NUCLEAR REGULATORY COMMISSION

Title: Advisory Committee on Reactor Safeguards Reliability and Probabilistic Risk Assessment Subcommittee

Date: Thursday, December 14, 2006

ESBWR Risk Management Overview

Squib Valve Example for N-2

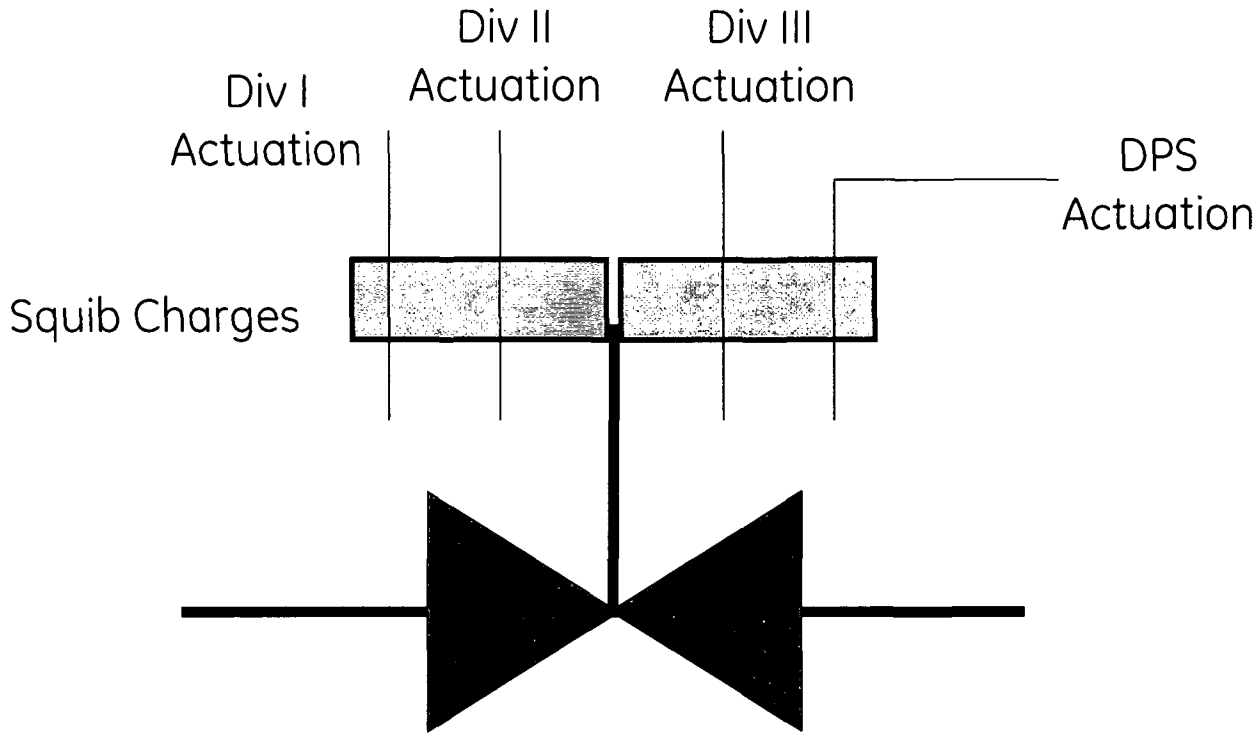
1 mean, after all you have no idea that you have the
2 wrong squib for the valves.
3 MEMBER SIEBER: It's sort of hard to test,
4 too.
5 MR. WACHOWIAK: But the weight -- well, in
6 that particular situation, I'm trying to see, we would
7 have an analogy here that we do have a test program
8 for our squib valves, but it's similar to what is
9 being done with the existing plants where the squib
10 charges would be taken out during an outage and some
11 sample is tested. So it's not that we would never
12 know, but, once again, if you put in a bad batch
13 during an outage, then there is not much you can do
14 about it until the next time you come down.
15 One of the things that we --
16 MEMBER SIEBER: You would have a portion.
17 MR. WACHOWIAK: Yes, that would --
18 MEMBER SIEBER: If you identified it
19 during operation, the next time you come down, about
20 10 minute after you identified it, right?
21 MR. WACHOWIAK: If all of the squibs were

1 squibs in or you have where you just put the valves.
2 MR. WACHOWIAK: Um-hum.
3 MEMBER ABDEL-KHALIK: Before you replace
4 them. But the value system, the testing program
5 doesn't indicate that those squibs are ever tested.
6 MR. WACHOWIAK: Well, we'll have to get
7 that updated. Those should also be tested just like
8 the DPDs. It's an ECCS system. The testing program
9 between the two systems should be, I would say, nearly
10 identical.
11 MEMBER ABDEL-KHALIK: I mean, my concern
12 is that, you know, this is presumably an industry that
13 would have, one would guess, Q&A standards comparable
14 to what you would have in the plant.
15 MR. WACHOWIAK: Right.
16 MEMBER ABDEL-KHALIK: And yet something
17 like this happens for different models, over a long
18 period of time and it seems anything -- logical that
19 the same thing could actually happen. You can have
20 squibs that are too small, that the valves wouldn't
